## 1806 Scott Street

Planning Rationale Addendum  
Zoning By-law Amendment + Site Plan Control  
September 5, 2023

Prepared for 2851944 Ontario Inc

Figure 7: Proposed building design for Submission 2, looking south toward Scott St

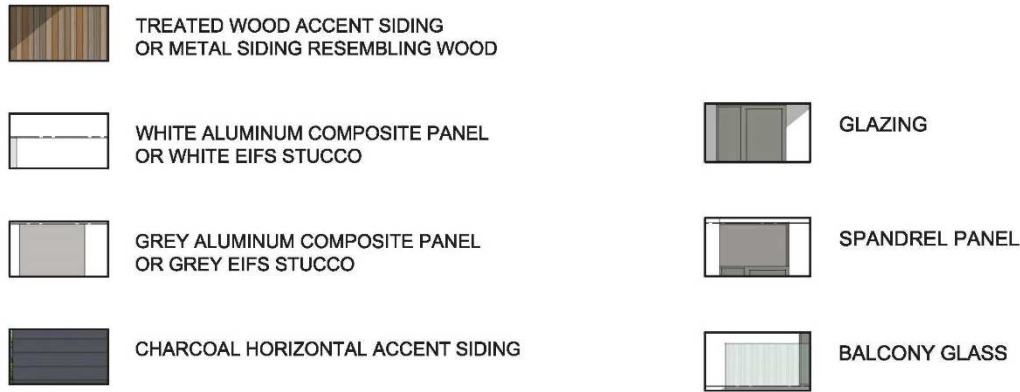
In response to feedback from the public, the building design has been adjusted to introduce additional colours to the ground floor, including a charcoal horizontal accent siding, shown below in Figure 7 and Figure 8. The charcoal siding emphasizes the ground floor and provides a transition in materials to add visual interest and break up the massing of the building.
